## ADDENDUM # 009

**Date:** 05/14/18

**RE:** Cherokee Nation Entertainment  
Tahlequah Casino

***Item 1***    Structure Summary of Changes

SHEET NUMBER:  
S3.2

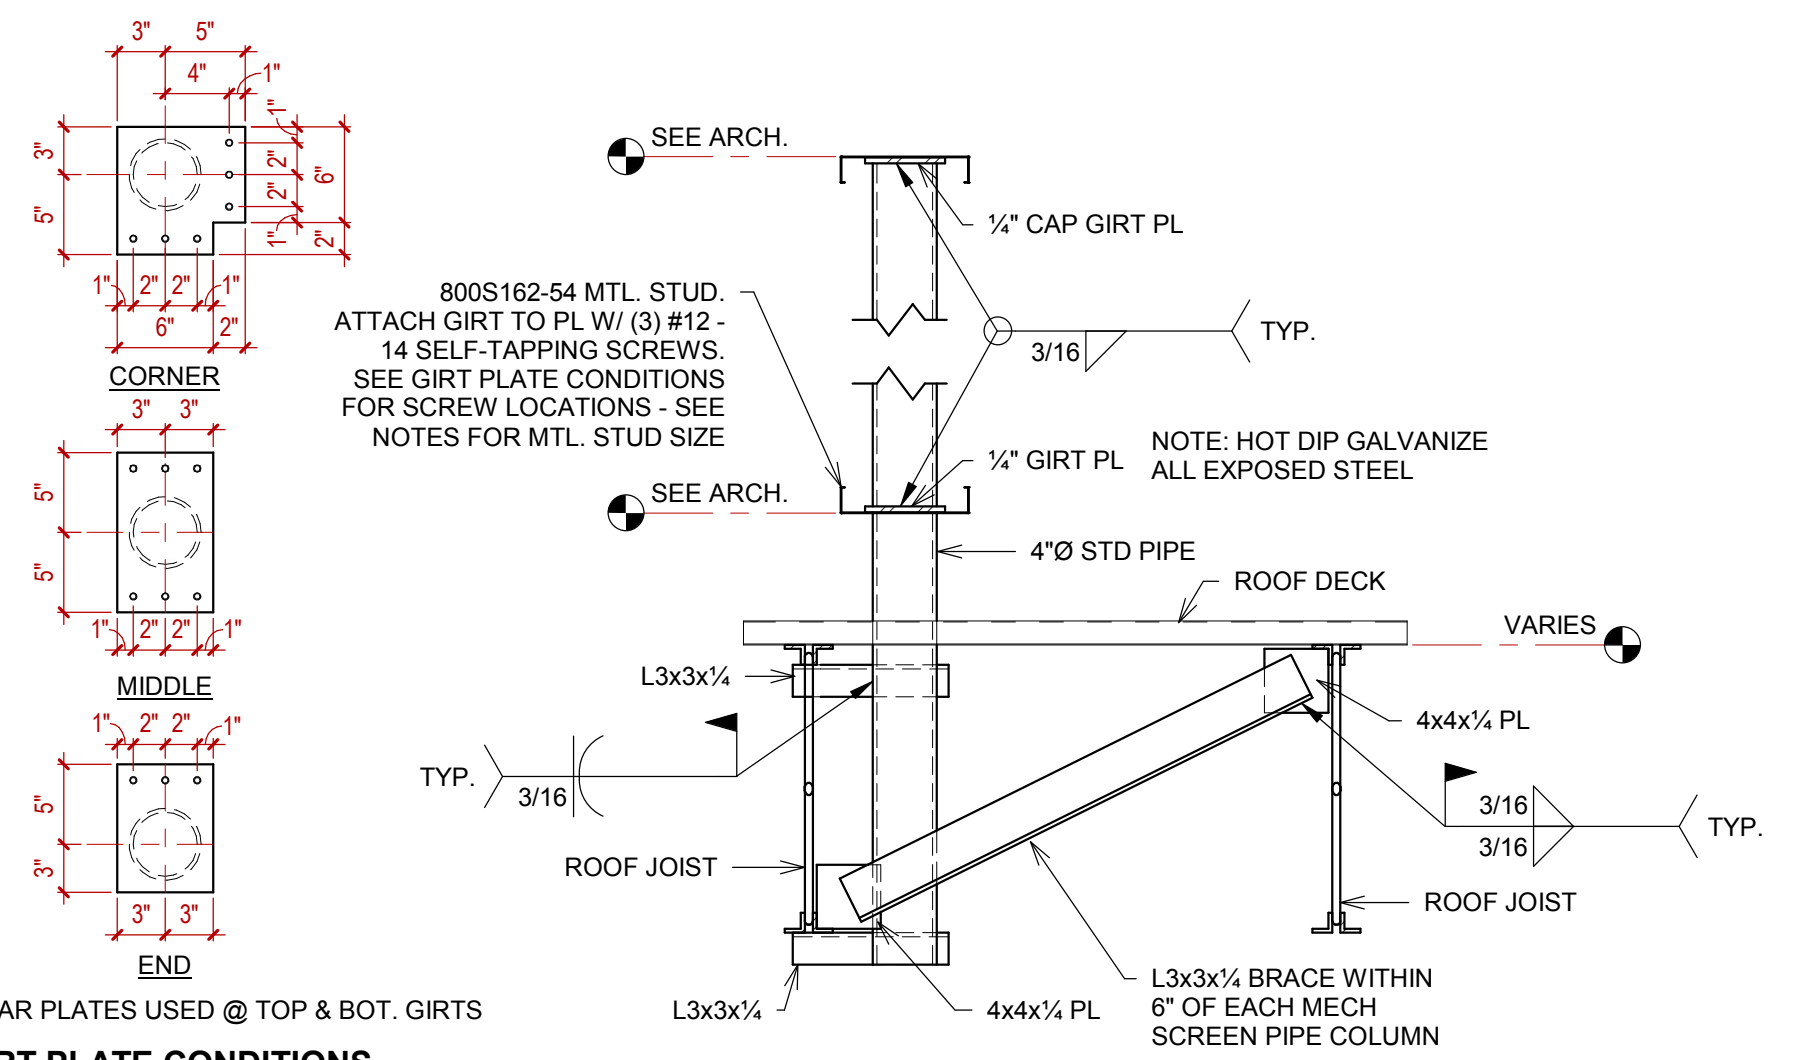
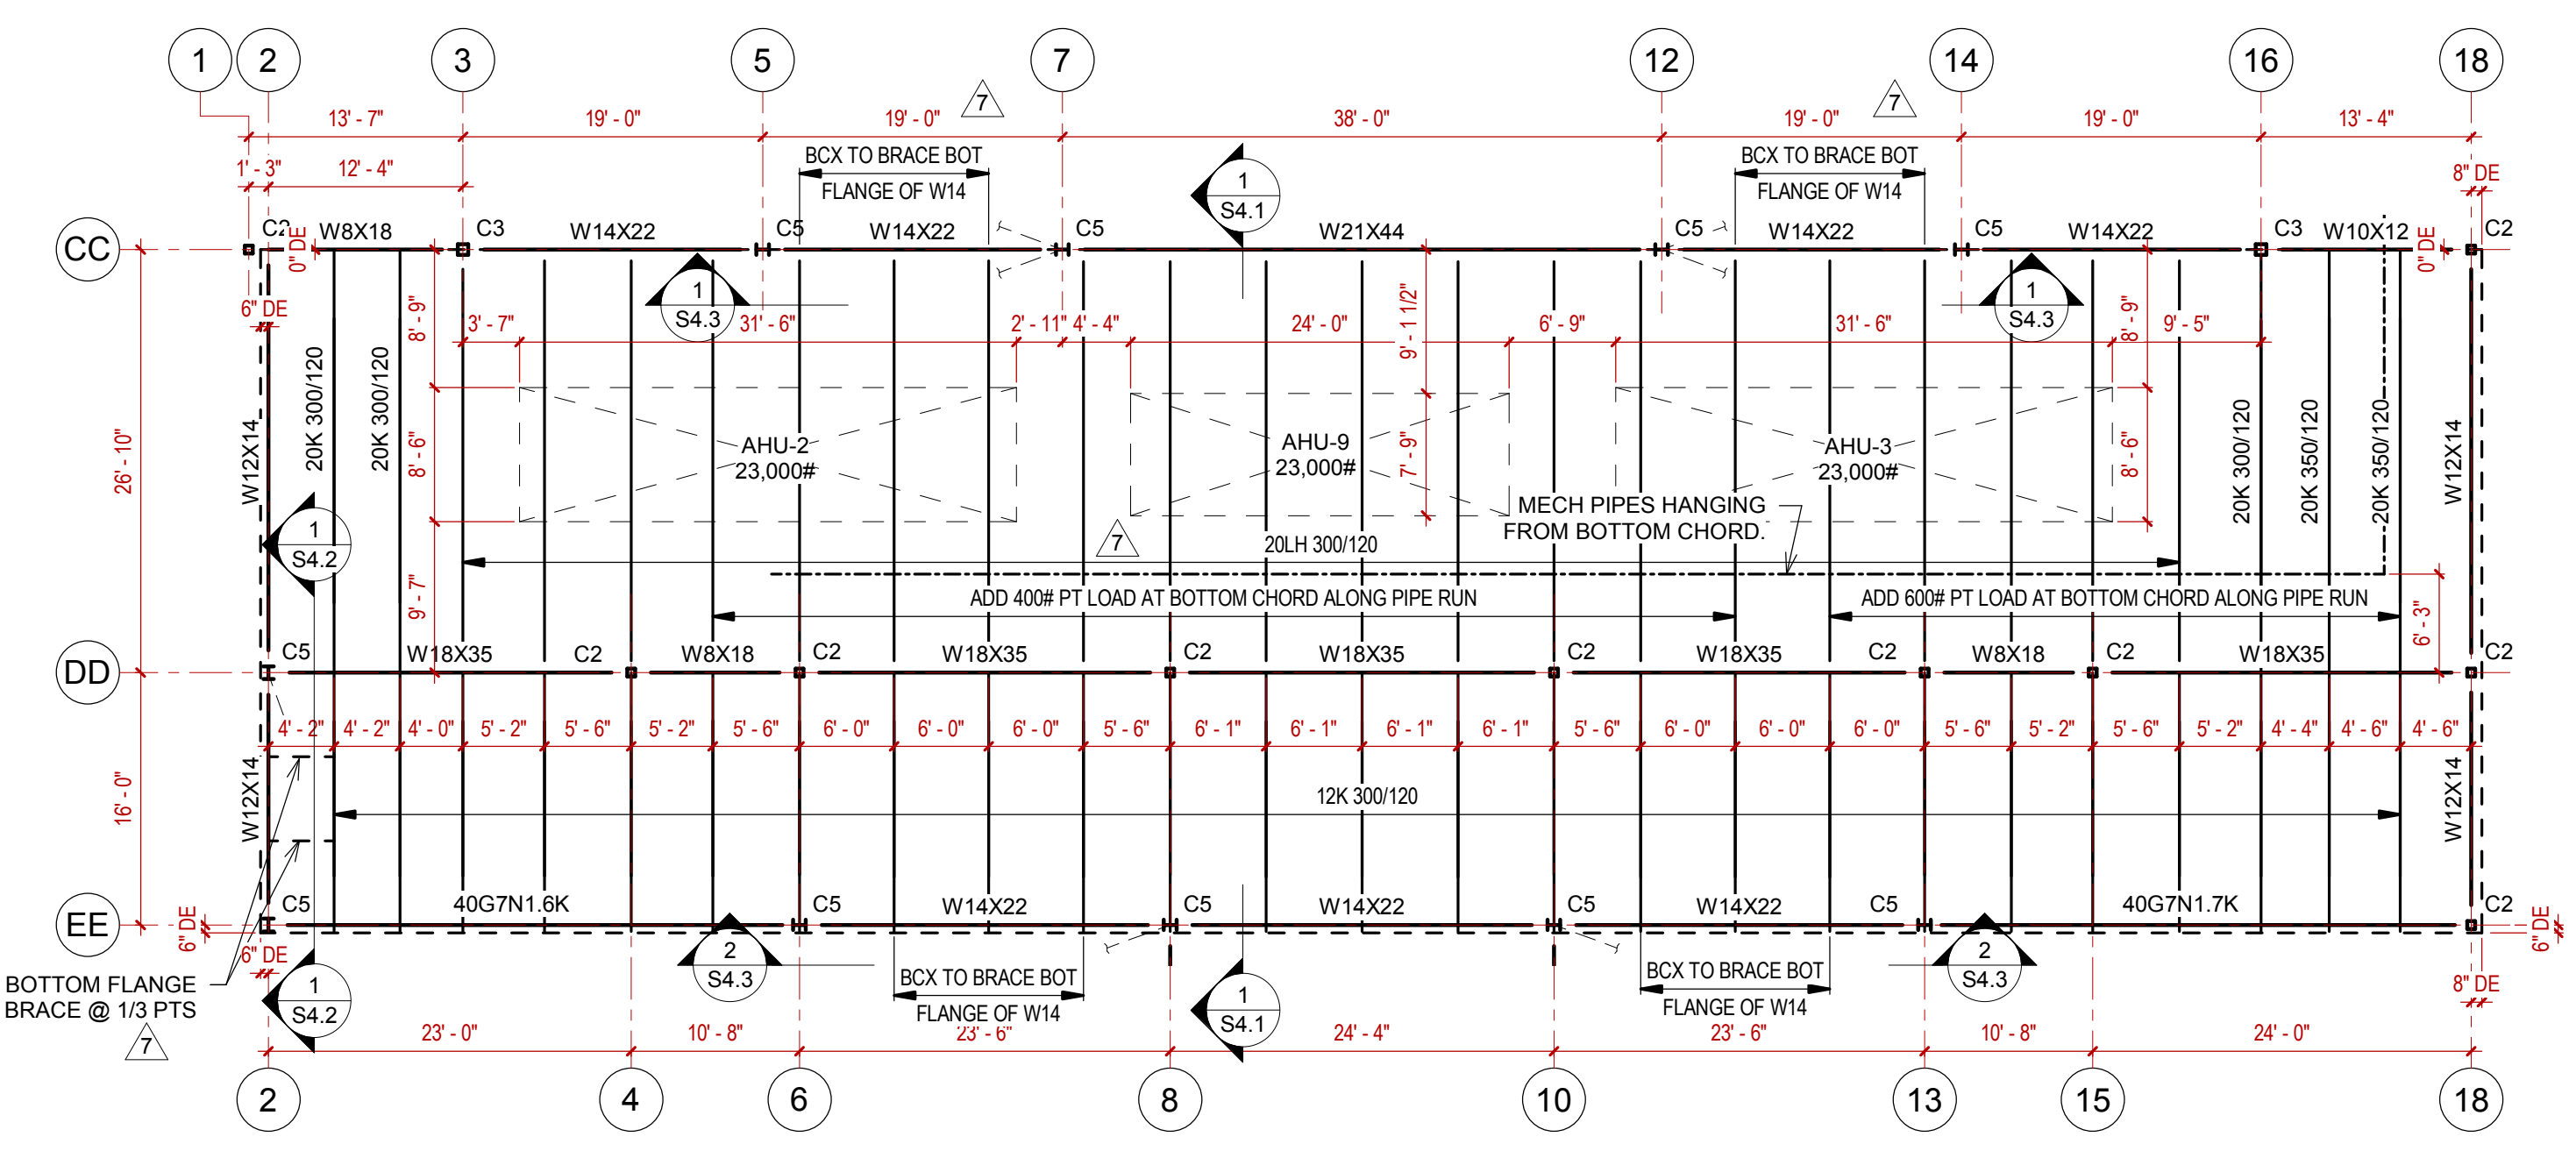
Sheet No.	Addendum
S3.2	<ul style="list-style-type: none"><li>• Moved roof joists at Grid 30.</li><li>• Added column brace at Grid 31.</li></ul>
S4.7	<ul style="list-style-type: none"><li>• Added diagonal brace at main entry porte-cochere</li></ul>
S4.8	<ul style="list-style-type: none"><li>• Added diagonal brace at main entry porte-cochere, grids 30 &amp; 31</li></ul>
S5.2	<ul style="list-style-type: none"><li>• Revised bar joist seat connections (5/S5.2)</li><li>• Deleted the JG to WF web connection (4/S5.2)</li></ul>
S5.3	<ul style="list-style-type: none"><li>• Added the revised JG to WF web connection.</li><li>• Added column brace detail.</li></ul>
